MVM PAKS II. ZRT.

**IMPLEMENTATION OF NEW POWER PLANT UNITS
AT THE PAKS SITE**

ENVIRONMENTAL IMPACT STUDY

CLARIFICATION OF FACTS

Figure 8-1: The impact of water retention actions characterised by alternatives of the Cunovo / Gabčíkovo barrage system in the low water level periods recurrent in every 20 000 on the security of the water extraction possibilities for the Paks Nuclear Power Plant (Danube, 1526.5 river km)

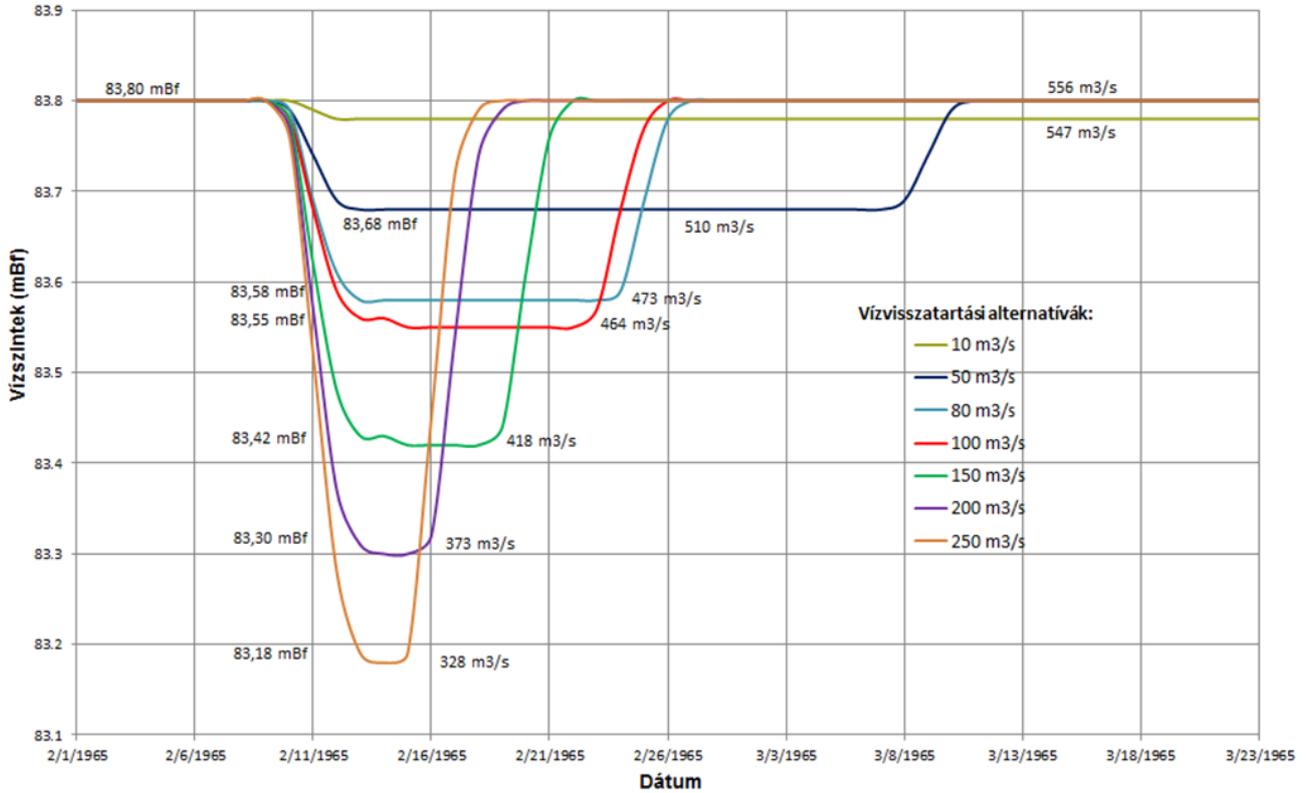
Out of the water levels mentioned above, the water level of 83.80 metres above Baltic sea level is a predicted lowest water level (mouth water level) expected in the year of 2032 and it is derived from the Paks city watermark post (1531.3 river km) to the nuclear power plant cross section (1527 river km). The other figure, 83.60 metres above Baltic sea level is the water level of the cold water channel measured at the water extraction plant at the time of low water flows and calculated with an average surface decline of 20 cm (embayment water level).

Based on the following figure of the EIS (11.9.2-5.) it can be concluded that the extreme low water level situations recurrent in every 20 000 years occurs in case of the current river bed at approximately ~83.80 metres above Baltic sea level.

When the more pessimistic linear trend is applied to the changes of the river bed, the low water stage river bed of the Danube will sink 1.8 metres below the level of the current river bed bottom by 2090, in other words the expected water level at extreme low water stage is 83.80 metres above Baltic sea level – 1.8 m = 82.0 metres above Baltic sea level. The current bed bottom level on the cold water channel is 81.0 metres above Baltic sea level (it is anticipated to be deepened), while the water extraction threshold of the operating pumps (MJO pumps) is at 83.6 metres above Baltic sea level (for the safety pumps the same is: BQS 83.50 metres above Baltic sea level) in the embayment.

In times of low water stage the surface decline on the cold water channel may be up to 20 cm, associated with a 82.0 metres above Baltic sea level - 0.2 m water extraction threshold, in other words a 81.8 metres above Baltic sea level operational water extraction threshold level would be necessary, which means that the threshold level of the operating pumps needed to be deepened by 1.8 metres (83.6 – 81.8 metres above Baltic sea level).

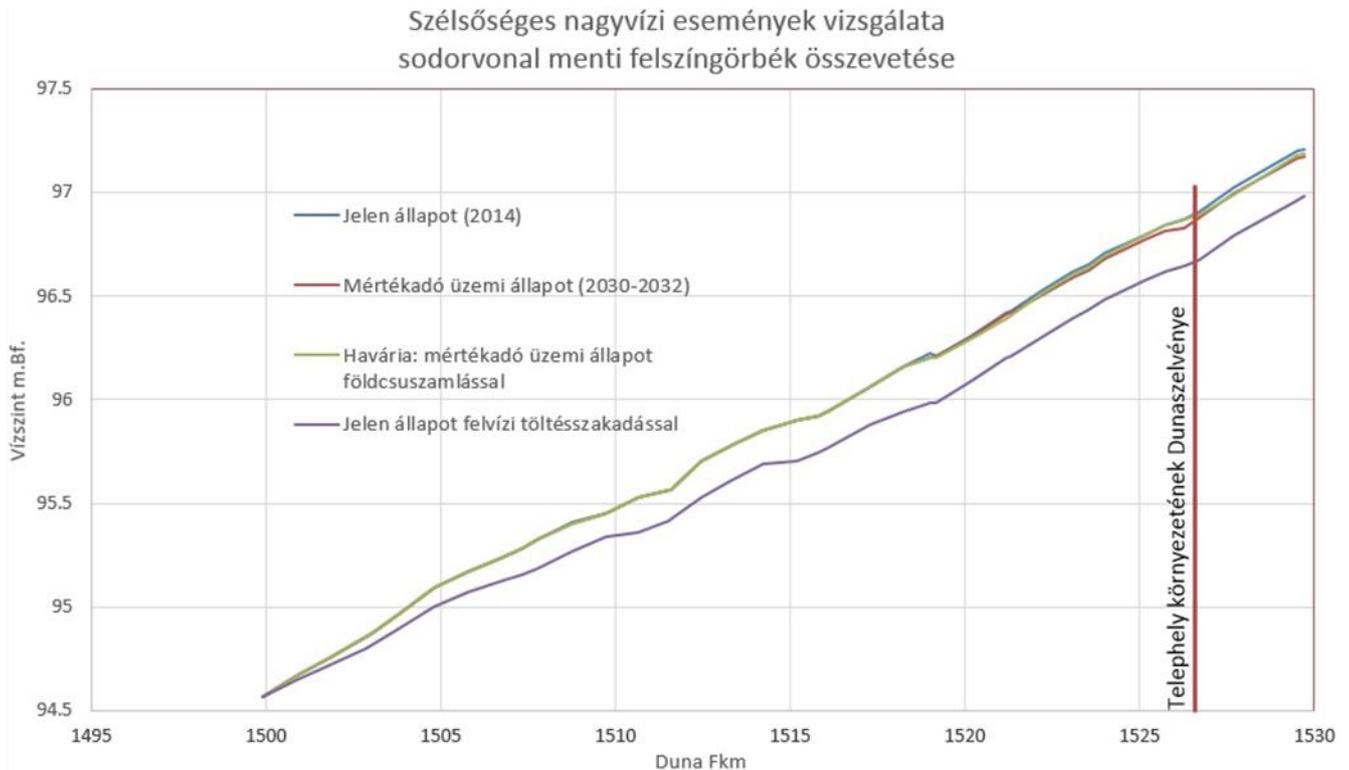
17 We cannot agree with the statement that the flood level determined for a frequency recurrent in every 20 000 years cannot be formed because the current level of the crest on the left bank embankment is lower than this (Chapter 11.7.1.2, Page 79). Flood levels exceeding the current elevation of the embankment crests can be successfully controlled by temporary control works as demonstrated in the past two decades on the river Tisza.

The water surface formed in the case of the water flow on the Danube recurrent in every 20 000 years (14 799 m³/s) was determined in the EIS using a 2D hydrodynamic model between the 1500 – 1530 river km profiles.

Namely, the current crest levels of the flood control works were elevated along the entire Danube section modelled (Danube 1500 – 1530 river km profiles) so that the water level reducing effect of the water spilling over the embankment crest at the current crest levels of the embankments (in the Power Plant profile the right bank crest level is currently at 96.30 metres above Baltic sea level, on the left bank 95.80 metres above Baltic sea level) were not taken into account.

Legend: A kibocsátási hőáram [m³/sec*°C] időbeli változása – Paks I – Paks II - Changes in discharge heat flux as the function of time [m³/s*°C] – Paks I and Paks II
 M [m³/sec*°C] – M [m³/sec*°C]
 t [év] – t [year]

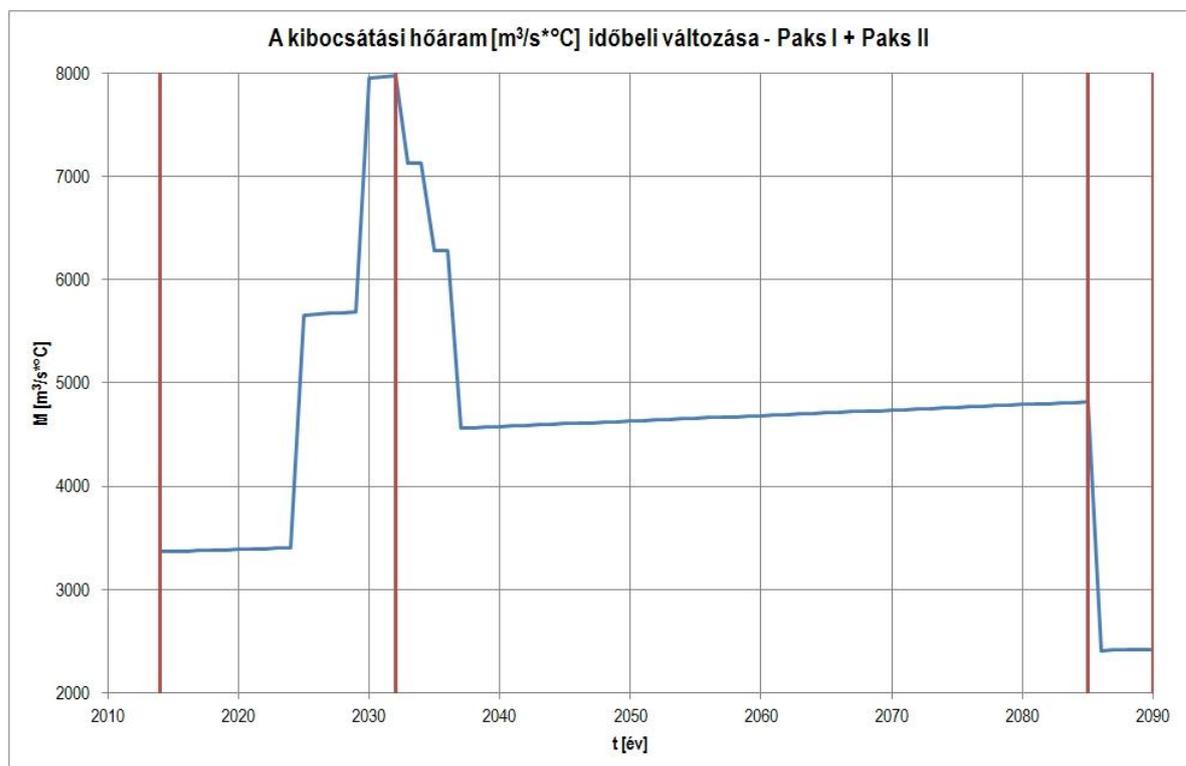
21 The statement in the documentation on the modelling (Page 140), states that the drop of flow in the hot water channel over time has a greater impact than the increase of the Danube water temperature derived from the climate change is not demonstrated by modelling, it should be supplemented. The Table in the beginning of Chapter 11.7.4.5.2 justified the extension of heat load studies to both various extreme Danube water flow rates on time horizons, since from the perspective of the aquatic life a very short term violation of the temperature limit may have a significant impact.

$$T_{m.h}^{parti} = \frac{M}{h(\pi D_{y,1} v_x x)^{\frac{1}{2}}} \exp\left(-\frac{v_x}{4D_{y,1} x} y^2\right)$$

M – heat flux, on which maximum water temperature depends in a linear manner,

q –hot water flow rate, changes over time ($q = q(t)$),

$T = T_{\text{Danube,max}} + \Delta T$, temperature of the discharged water (ΔT : heat gradient), changes over time ($T = T(t)$).

Figure 22-1: Calibration of the River2D model for 1242 m³/s Danube flow rate

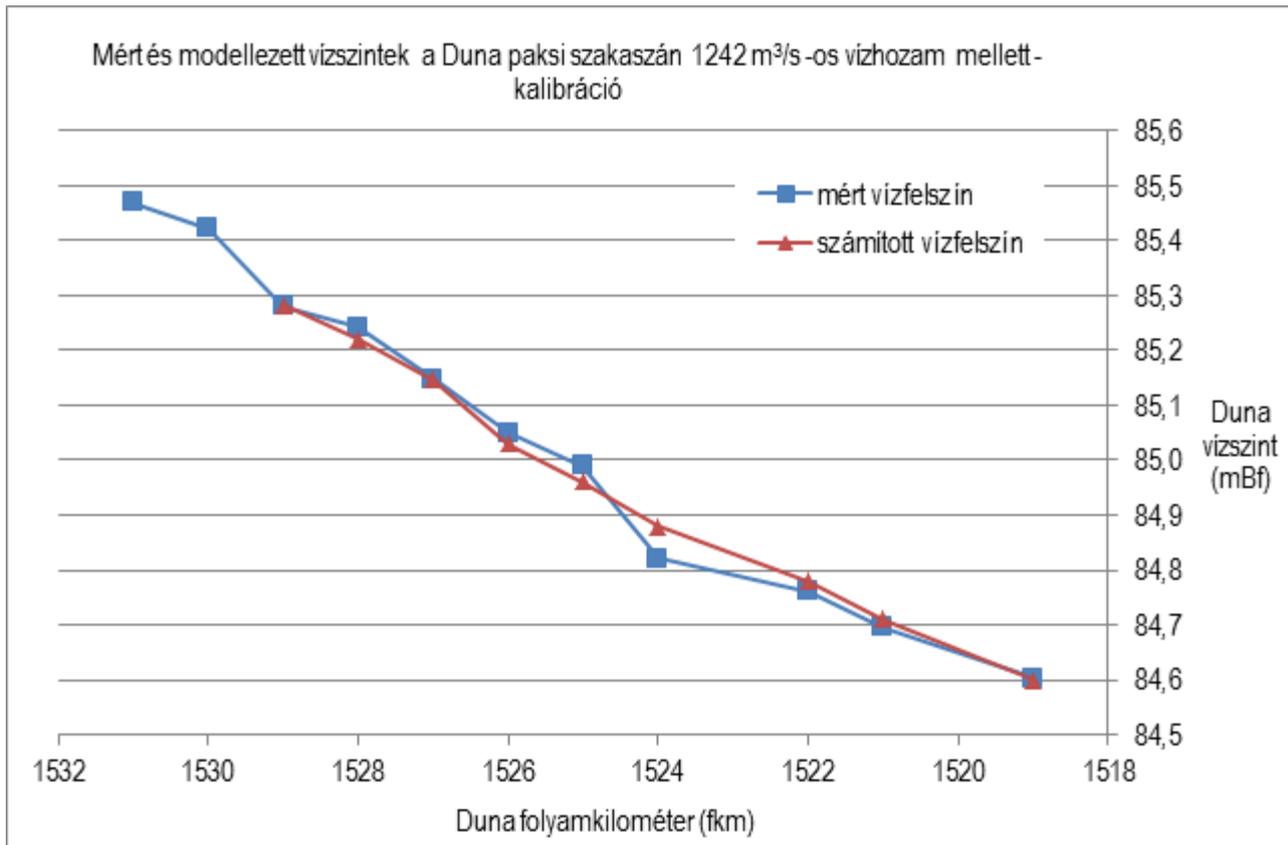
22 Only two figures were found about the examination of the flow conditions in Chapter 11.8.1.2. The impact of the erection of Paks II on the flow space and river morphology changes in the Danube, which contain the depth integrated flow fields associated with a flow of 2300 m³/s on the Danube and a water extraction/flow rate of 100 m³/s. The EIS does not contain any such results from series of tests which would have applied higher level of water use and lower levels of Danube flow rates, although the design state for the purpose of navigation would be represented by extreme low water flows and the highest levels of water use throughout the operation period.

The 2D flow calculations have been completed taking into account the nearly permanent surface curve and water flow rate of (1242 m³/s) measured on 6 October 2011:
